**Economic and Social Council**

Economic Commission for Europe**Inland Transport Committee****World Forum for Harmonization of Vehicle Regulations****Working Party on Passive Safety****Fiftieth session**

Regulation No. 16 (Safety-belts)**Proposal for Supplement 3 to the 06 series of amendments****Submitted by the Chair of the informal group on Child Restraint Systems ***

Figures 1 to 7, item 2 of the Key, amend to read:

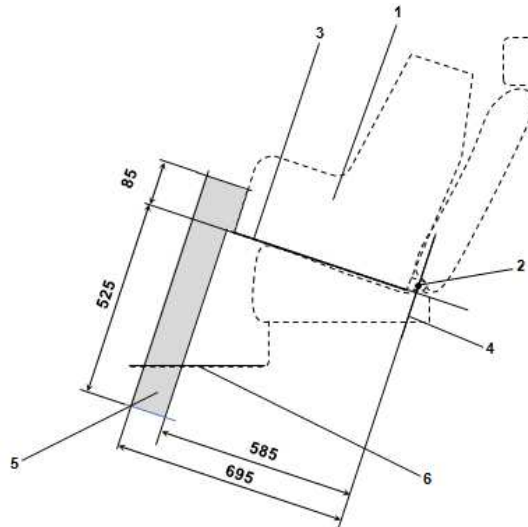
1. ...
2. Dashed line marks area where a support leg, or similar, of a specific vehicle CRS is allowed to protrude.
- ..."

Figure 9

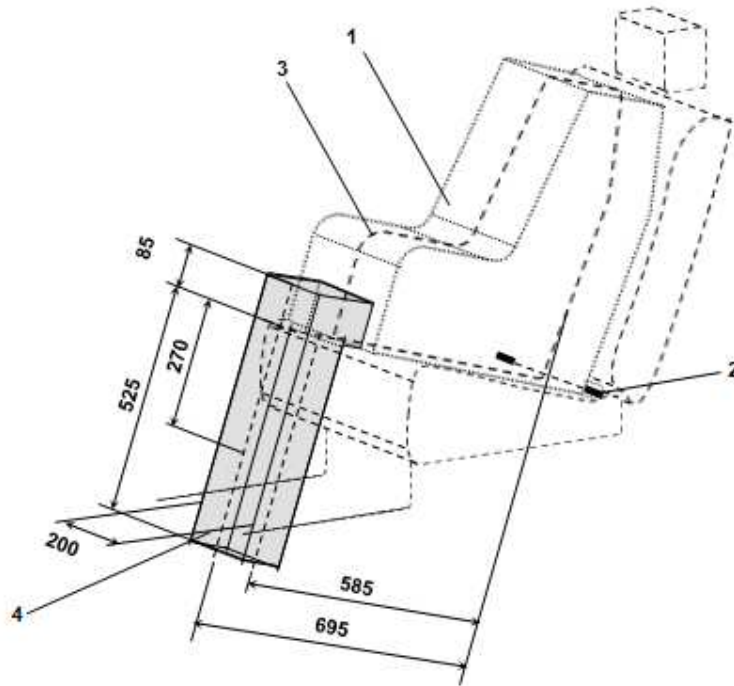
Insert new Figures 8 and 9, to read:

3D view of the i-Size support leg installation assessment volume for assessing compatibility of the i-Size seating positions with support legs of i-Size child restraint systems

1. Child Restraint Fixture (CRF).
2. ISOFIX low anchorages bar.
3. Median longitudinal plane of the CRF.
4. i-Size support leg installation assessment volume.
